Response to Submissions Report – New M5

City of Sydney's response to the submissions report on the New M5

Figure 9-73 Annual mean PM_{2.5} at community receptors (2021-DS and 2031-DS)

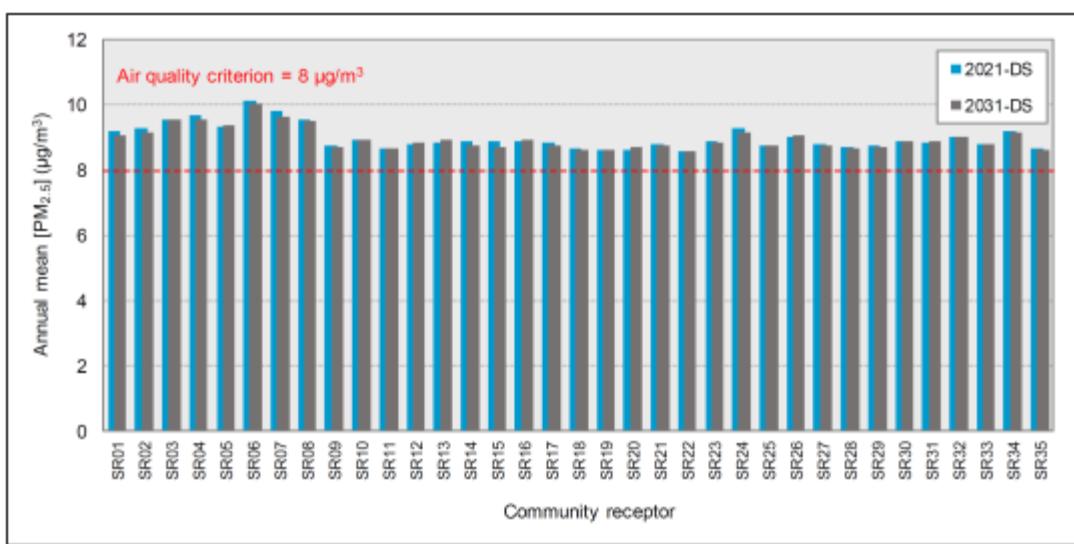
The current annual average PM_{2.5} levels are already above 8 µg/m³ and the 24-hour mean is almost 25 µg/m³ (see images below), which are the current standards. These levels will increase with the project.

The response in the Submissions Report does not clarify this. A contingency plan is not mentioned.

The City recommends that the air quality assessment is re-analysed based on the agreed amendments to the AAQ NEPM standards, and what measures will be put in place to meet the standard.
